N9952A-01B

Modification Recommended Service Note

N9952A – 50 GHz FieldFox RF analyzer

The Problem – The internal Main Memory (SD) card can fail. Refer to www.keysight.com and the **Contact Keysight** link.

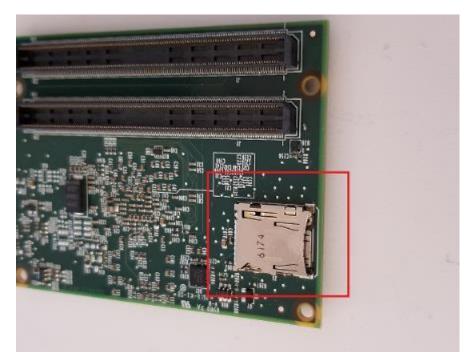
c. Using an Exacto Knife remove the Epoxy bridge holding the SD Card into the SD card socket.

d. Use caution to not damage the socket or other parts of the CPU board.

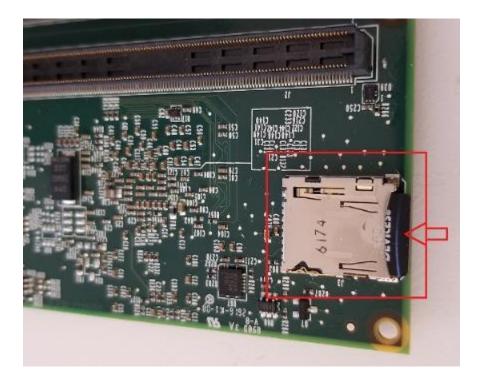
f. Here are the Old and New SD cards. The old SD card (Patriot) is on the left. The New (Delkin) is on the right.

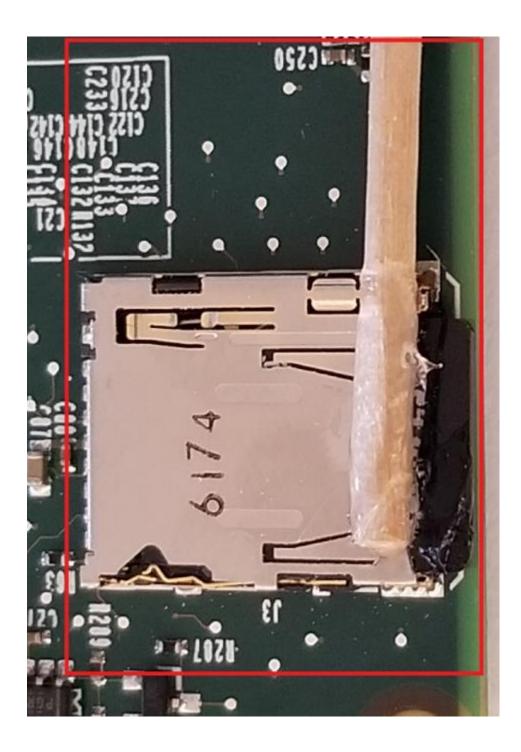
g. Insert the NEW SD card into the SD card socket and press it in until you hear a click, then release. The SD card is now locked in the socket.

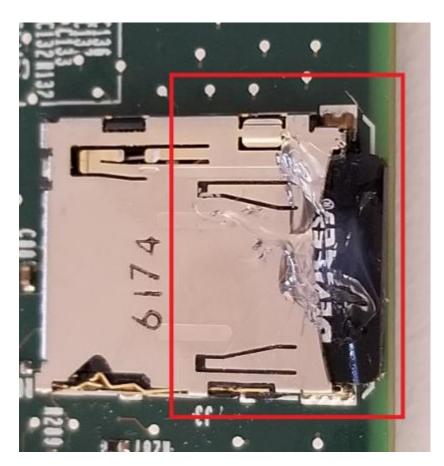
h. It is now necessary to add a small amount of RTV (part number 0470-0450) to bridge the SD card to the SD card socket. Using a wooden Q-Tip place a small amount of RTV on both the SD card and the socket.

i. Set the CPU aside for about 20 min to allow the RTV to harden. It will not become completely hard and may be a bit tacky to the touch. This is ok and it will completely dry in the unit.
4. Refer to page 145 in the Keysight FieldFox Handheld Analyzers Service Guide (N9927-90003) located here http://literature.cdn.keysight.com/litweb/pdf/N9927-90003.pdf for re-assembly.
5. Once re-assembled, it is time to load the OS and FW on the SD card.
